# Access Compliance Report

## Public Rights-of-Way

Intersection ID: 25670	Main Street: EDGEWOOD GROVE TL	Cross Street: WOODLEIGH OAKS DR	Location: NE
ADA ID: 46505FD1E804	Ramp Type: Perp	Initial Pass/Fail: Fail	Overall Compliance: No
Severity Score: 22.5			
Codes/Mitigation Info/Possible Solution		Field Measurements/Component Compliance

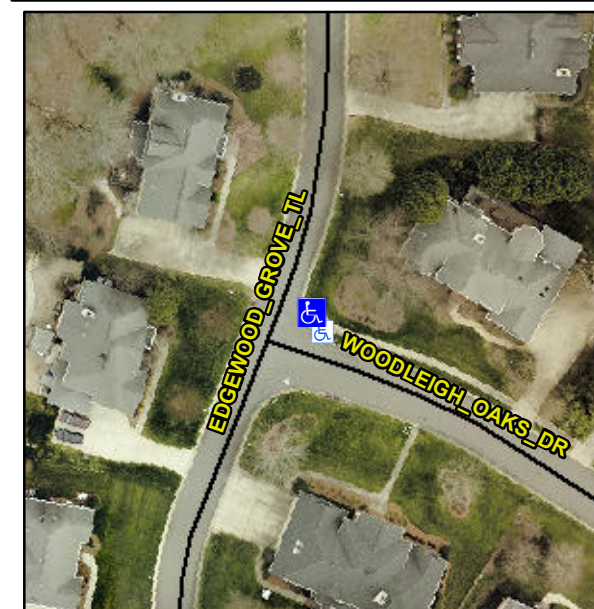
**Not Found, R304.5.1, R304.2.2, R304.5.3**

Compliance	Description	Data	Compliance	Description	Data
N/A	Ramp Length (in)	47.0	No	Ramp Slope (%)	9.0
No	Ramp Width (in)	45.0	No	Ramp XSlope (%)	3.2
N/A	Flare Type LT	N/A	N/A	Flare Type RT	N/A
N/A	Flare Slope LT (%)	N/A	N/A	Flare Slope RT (%)	N/A
N/A	Flare Traversable LT?	N/A	N/A	Flare Traversable RT?	N/A
N/A	Landing Length (in)	N/A	N/A	DWS Provided?	N/A
N/A	Landing Width (in)	N/A	N/A	DWS Contrast?	N/A
N/A	Landing Slope (%)	N/A	N/A	DWS Length (in)	N/A
N/A	Landing X Slope (%)	N/A	N/A	DWS Full Width?	N/A
N/A	Landing Curb? (Y/N)	N/A	N/A	DWS Offset (in)	N/A
N/A	Shared Landing?	N/A			
N/A	Gutter Ponding?	N/A	N/A	Gutter Slope (%)	N/A
N/A	Gutter Lip Ht (in)	N/A	N/A	Gutter X Slope (%)	N/A
N/A	Painted X Walk1?	No	N/A	Painted X Walk2?	N/A
	X Walk 1 Direction	To SW		X Walk 2 Direction	N/A
N/A	X Walk 1 Width (in)	N/A	N/A	X Walk 2 Width (in)	N/A
	X Walk 1 Slope (%)	2.2		X Walk 2 Slope (%)	N/A
	X Walk 1 X Slope (%)	1.4		X Walk 2 X Slope (%)	N/A

**Remove & Replace Entire Ramp.**
